3 Volt Intel[®] Advanced+ Boot Block Flash Memory

28F800C3, 28F160C3, 28F320C3, 28F640C3

Specification Update

Order Number: 297938-014

2. 28F320C3xC Reset Failure

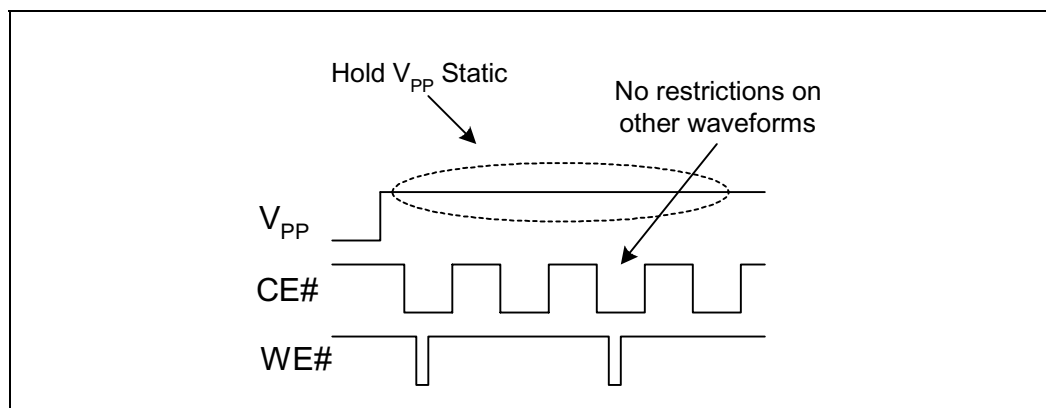
Problem: The 0.18 μm 28F320C3xC devices can unintentionally reset under certain conditions where V_{PP} toggles.

4) Wait 2 ms after a V_{PP} transition to access the flash device, as shown here.

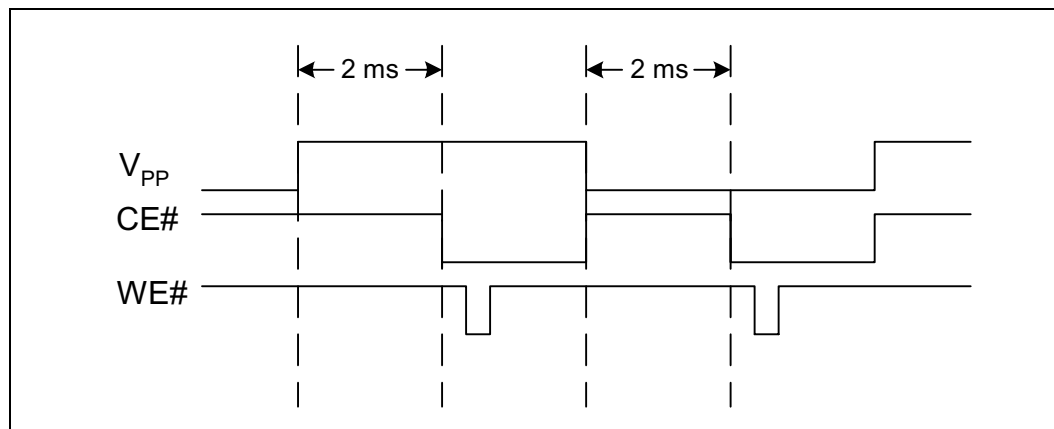
Implication: When the reset occurs, any command being executed is interrupted and the flash switches to read array mode.

- 1) Tie V_{PP} to V_{CC} ;
- 2) If the third and forth digits on the top side FPO mark (third line) is equal or greater than “23”, then V_{CC} may be set from 2.7v to 3.3v. V_{CC} must not exceed 3.3v
- 3) Set V_{PP} to a static high or static low level as shown here; and

Figure 1. Workaround Placement

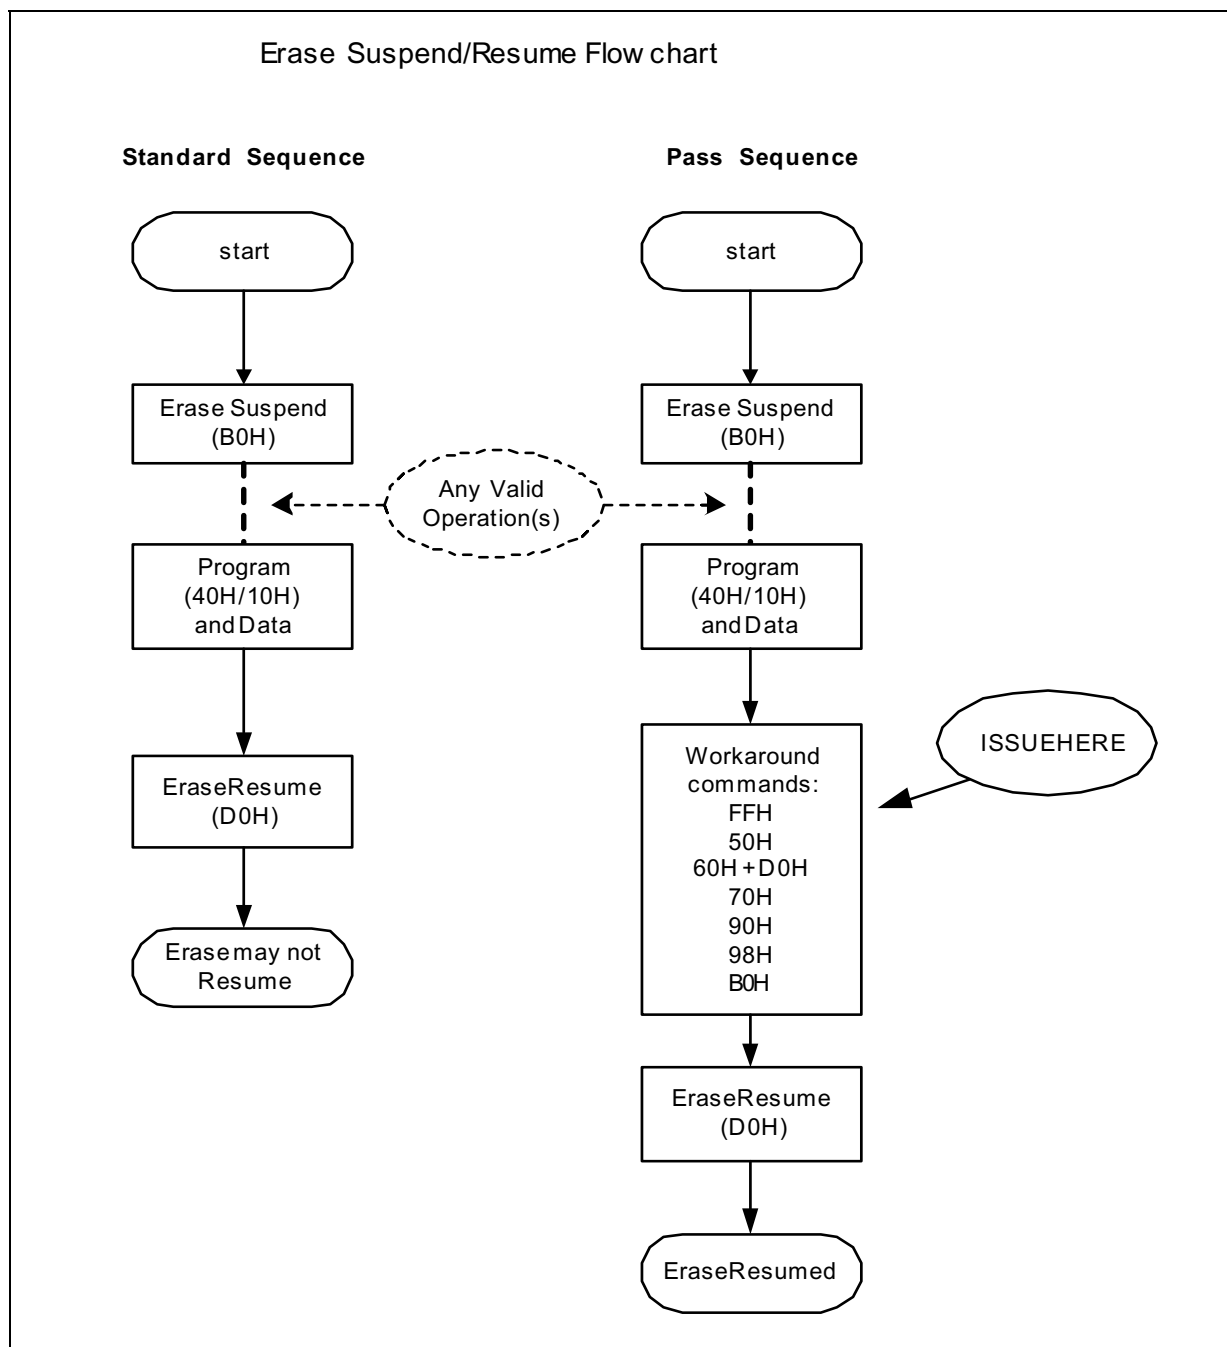
Problem: On the 0.18μm 28F160C3xC devices, a design anomaly was discovered. During an Erase-Suspend operation, if the Program (40H/10H) sequence is executed, under limited conditions the proceeding Erase Resume command (D0H) may not actually resume the device. No customers have reported failures in product applications. Customers who use any version of FDI (Intel Flash Data Integrator) software will not see this issue. If the Read Array command is issued prior to the Erase Resume command, users will not see the issue (typical in XIP applications).

Implication: The Resume Command (D0H) may be ignored by the device and will not correctly resume. The device will appear to remain in suspend (via status register). After a reset of the flash device the status register will clear. This failure has been recreated in a lab environment only.

1. If FDI (Intel Flash Data Integrator) software is used, users will not see the issue.
2. During an Erase-Suspend (B0H), user must issue any of the following commands after issuing the Program (40H/10H) and data sequence but before issuing the Erase-Resume (D0H) command.

5. 28F160C3xC and 28F640C3xC Lock/Unlock/Lock-Down Operation

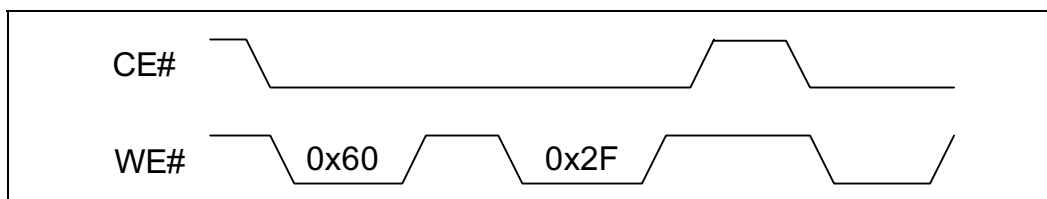
Problem: On the 16Mb and 64Mb 0.18µm devices, if CE# is deasserted after any block lock operation and before the next write sequence, the part may perform the same operation on additional blocks. (See waveform below.)

Implication: When CE# is deasserted after performing a block lock operation to a specific block and prior to the next write sequence, other blocks may perform the same operation.
